From: Delroy Johnson <Djohnson@norwood.dev>
Sent: Tuesday, April 6, 2021 4:32 PM
To: Marc Whorton
Subject: Fwd: Message from KM_C364e

From: Scott Ridings <sridings@wescottfire.org>
Date: April 6, 2021 at 4:19:27 PM MDT
To: Delroy Johnson <Djohnson@norwood.dev>
Subject: Re: Message from KM_C364e

ACCEPTABLE ALTERNATIVE
TO 120' HAMMERHEAD

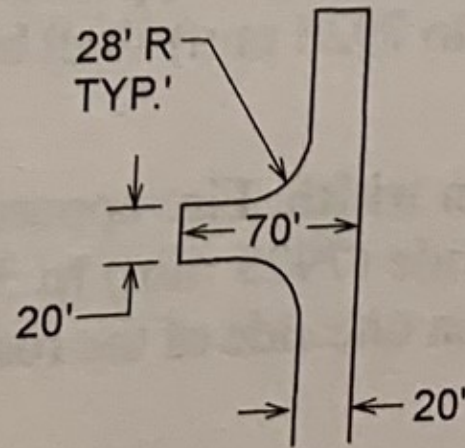
Marc, see below and attached, the fire department has approved the design, you may just have to show the 20 foot and 70 foot as per his very last example, and I am assuming that is unpaved. So we would just have 12 feet of that paved.
